**Tool &  
Product  
Update**

### C50L to MG Conversion

No. **242**

Figure shown below illustrates difference between C50L and MG Collets.

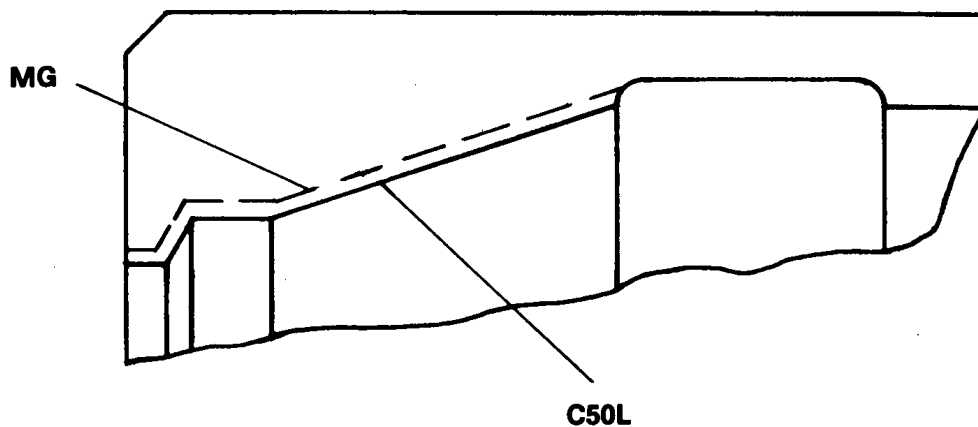
Conversion Kits 113409, 113408, 113407 and 113406 are obsolete and no longer available.

In 1980, conversion kits were offered to encourage C50L users to convert to the Magna-Grip Fastening System. Kingston Product Engineering has redesigned Magna-Grip collets as illustrated below and, therefore, C50L collets are not interchangeable with MG collets—C50L collets cannot be used in MG noses.
